February 24, 2023

**CLARIFICATION NUMBER 1
TO
CONTRACT DOCUMENTS
FOR
THE HURON COUNTY
SALT STORAGE BUILDING ADDITION ARPA**

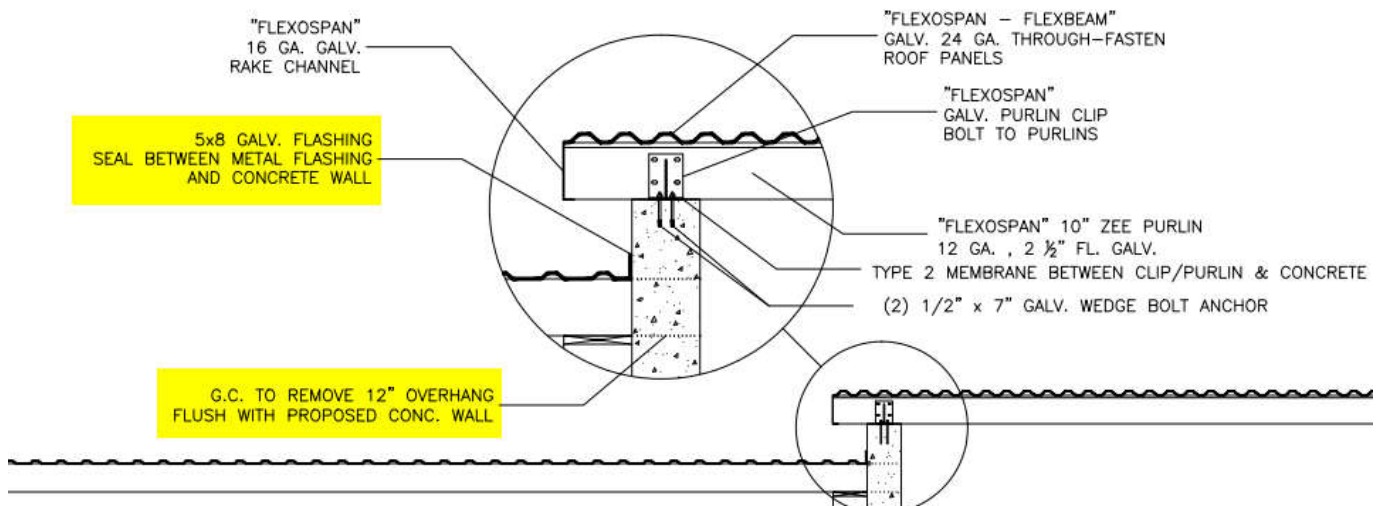
Question 3: *Is the existing roof to be removed and replaced with new?*

Answer 3: No. The existing salt storage building's roof shall only have the overhang removed and flashed into the proposed wall. Portion of Detail from Sheet A2.1. See full plan set for full detail.
